City of Sherwood

Planning Commission
Agenda

January 2, 1986
7:30 p.m., Senior/Community Center
855 No. Sherwood Blvd.

RE: Request by P.M. Marshall for a Minor Land Partition Taking 3.3 Acres from Tax Lot 501, Map 2S-1-28A, and Consolidating it with the Adjoining Tax Lot 601.

MINOR PARTITION SKETCH
CITY OF SHERWOOD
MARSHALL PROPERTY

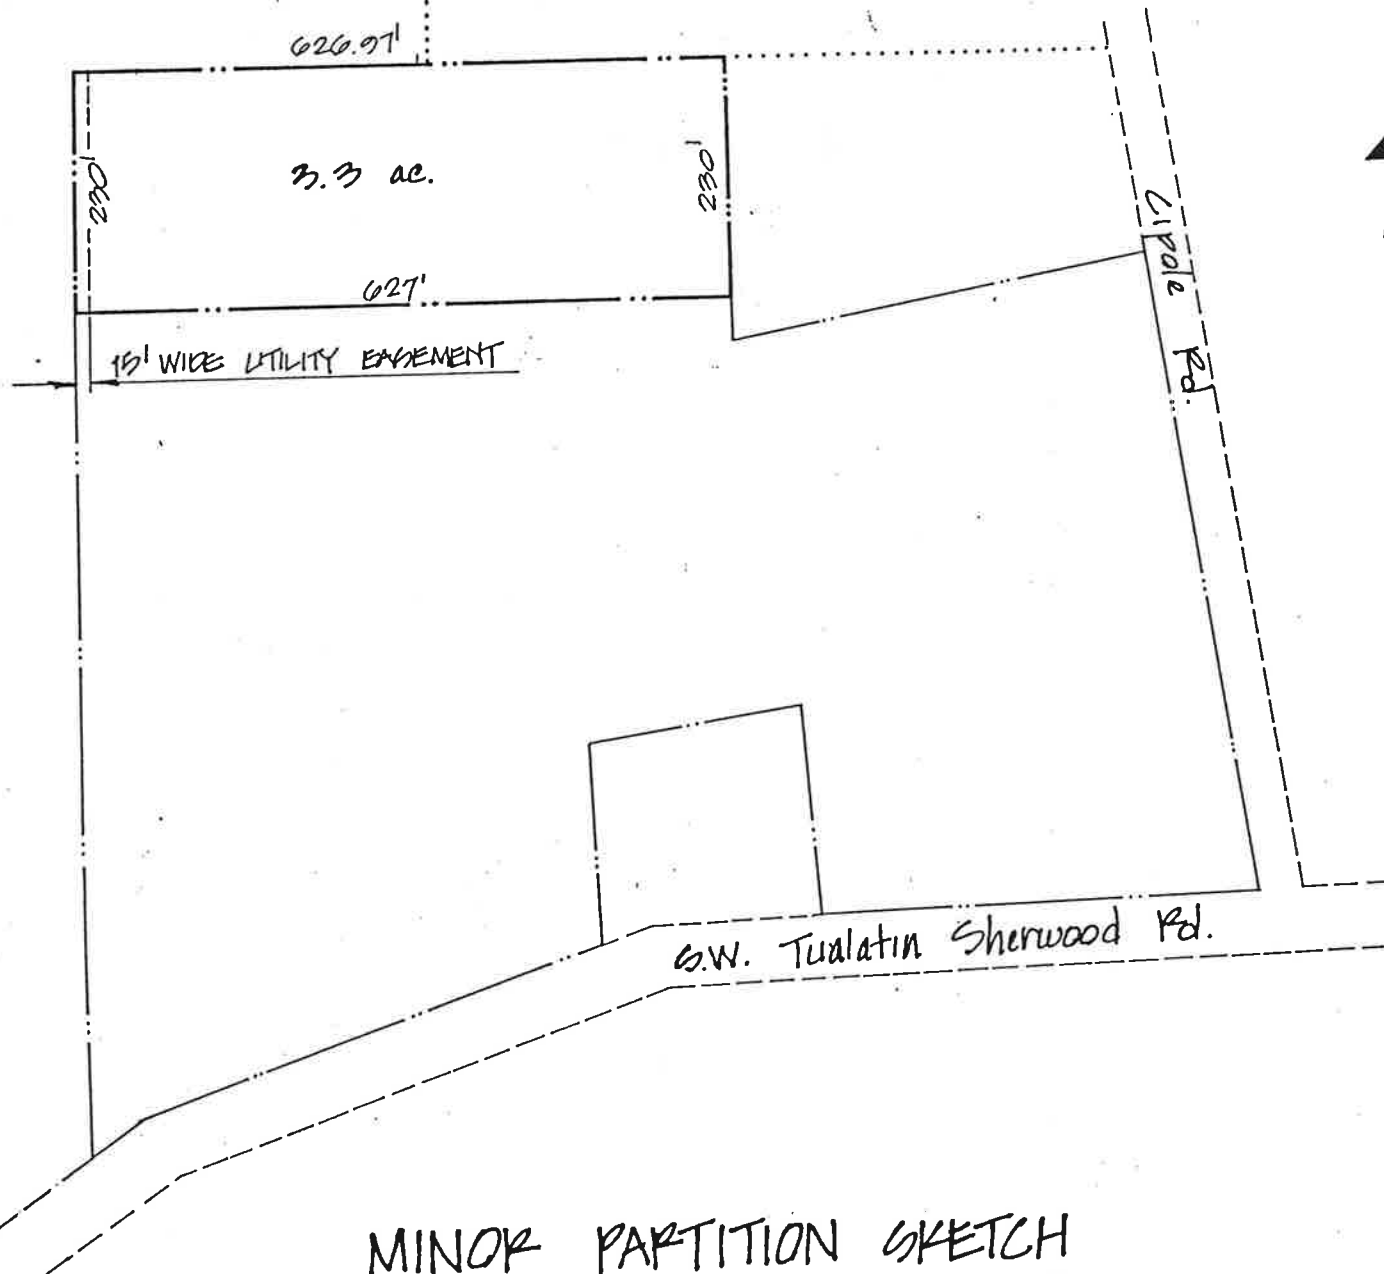
1. The subject parcel, Tax Lot 501, is currently 18.27 acres. The partition request is to split 3.3 acres from the lot and combine it with the adjoining Tax Lot 601.

5. The proposed partition does not create a road; the lot gains public access from Cipole Road through its consolidation with Tax Lot 601. An access plan has not been identified.

8. Division of Tax Lot 501 as proposed does not interfere with future access to adjoining lots.

9. Required dedications from Tax Lot 601 to Cipole Road, a minor arterial, have been satisfied. Curb, gutter and sidewalk improvements have not been made.
10. The site is not within any identified floodplain or significant natural area.

1. **The applicant shall enter into a non-remonstrance agreement for future road improvements to Cipole Road.**
2. **Retain existing trees, as possible, that act as a natural buffer between the proposed partition and adjoining lots.**
3. **Incorporate into the approval any requirements of the Tualatin Fire District, including an acceptable access plan to the parcel.**

SITE
INCLUDES PROPOSED
AND/OR PARTITION LOT
OF APPROX. 3.3 ACRES

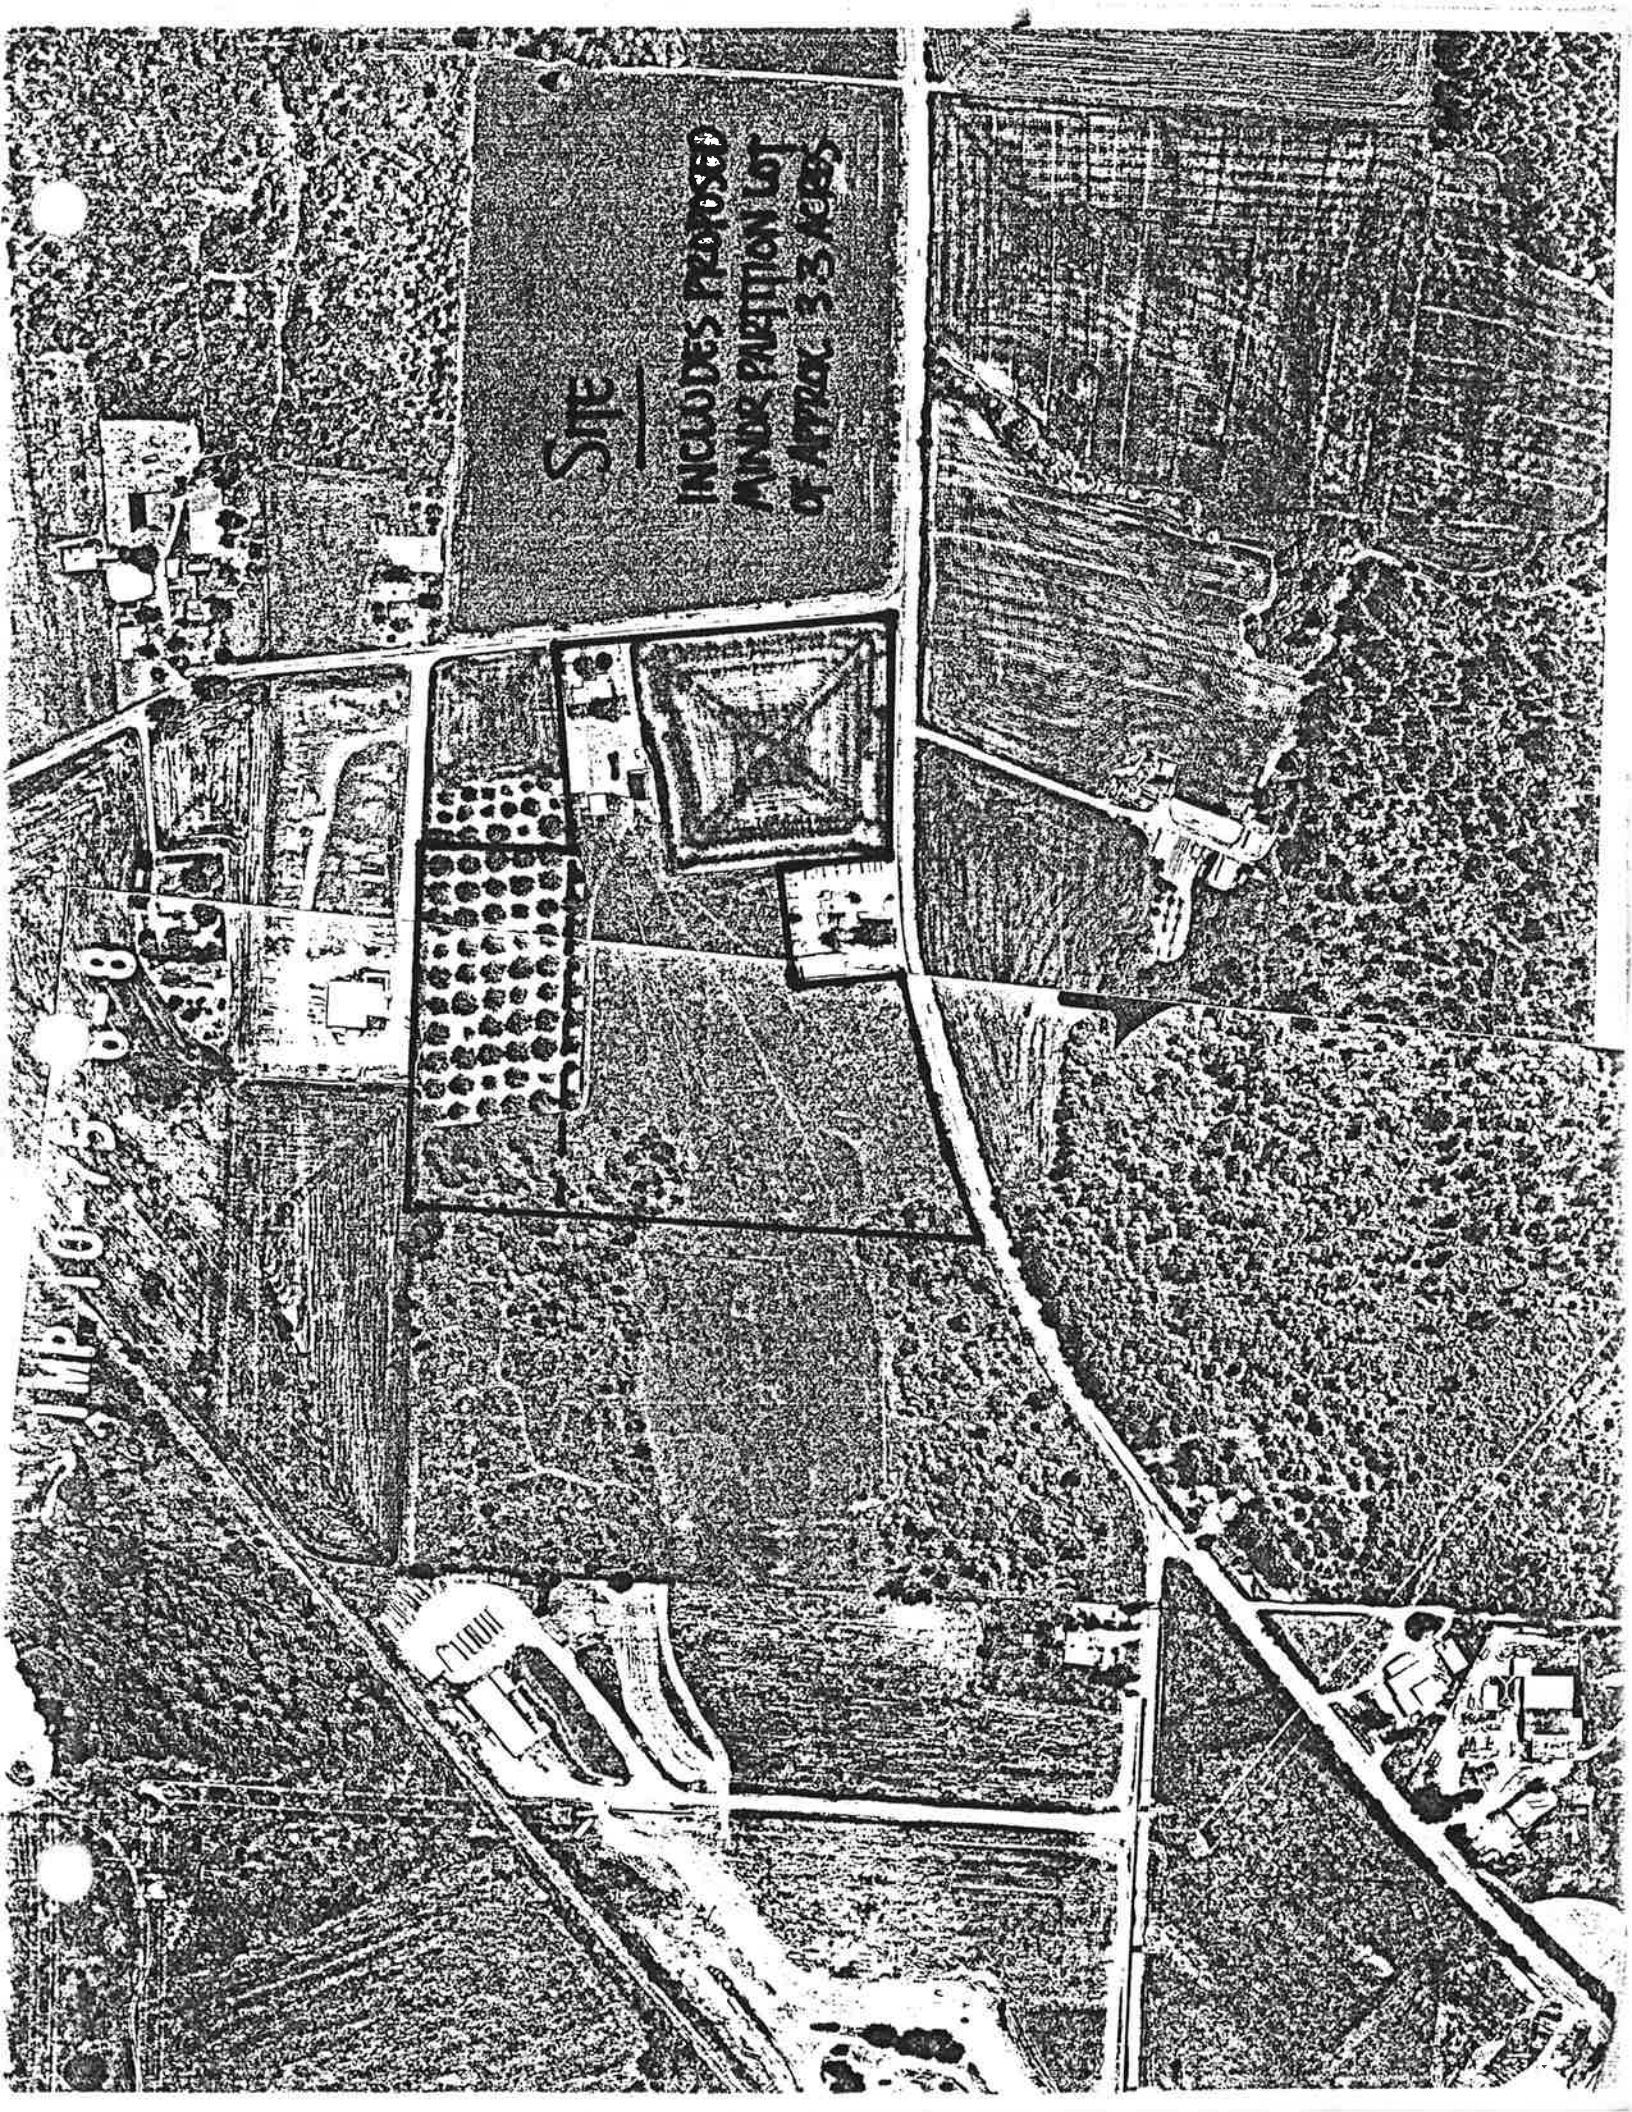
6. The GI zone requires a minimum lot width of 100 feet. The proposed lots 1 and 4 do not meet the width requirement.

18. There are no significant natural or historical features on the subject property.
19. The Code recommends an 1800-foot separation between street accesses on an arterial street. This recommendation is not met on either road. The cul-de-sac is about 300 feet from Chavez Lumber, and about 900 feet from Cipole Road. Access onto Cipole Rd. from proposed Lots 7, 8 and 9 would be about 200 feet apart from each other, as well as the parcel to the north.

20. The subject parcel is about 500 feet from the Edy Road, Tualatin-Sherwood Rd. intersection.
21. The proposed plan does not attempt to consolidate access with adjoining Tax Lot 502. Development of an additional access road from that parcel, even closer to a busy intersection, will further conflict with access control policies of the Comprehensive Plan.

- 1, Revise the dimensions of Lots 1 and 4 to comply with the minimum width requirement of 100 feet.**
- 2. The applicant shall enter into a non-remonstrance agreement with the City for future road improvements to Cipole Rd. and Tualatin-Sherwood Rd.**
- 3. Consider retaining existing vegetation until specific development plans are submitted to the City.**
- 4. Consider a shared access to Tualatin-Sherwood Rd. with Tax Lot 502, or consider providing access to the parcels from Cipole Road only.**
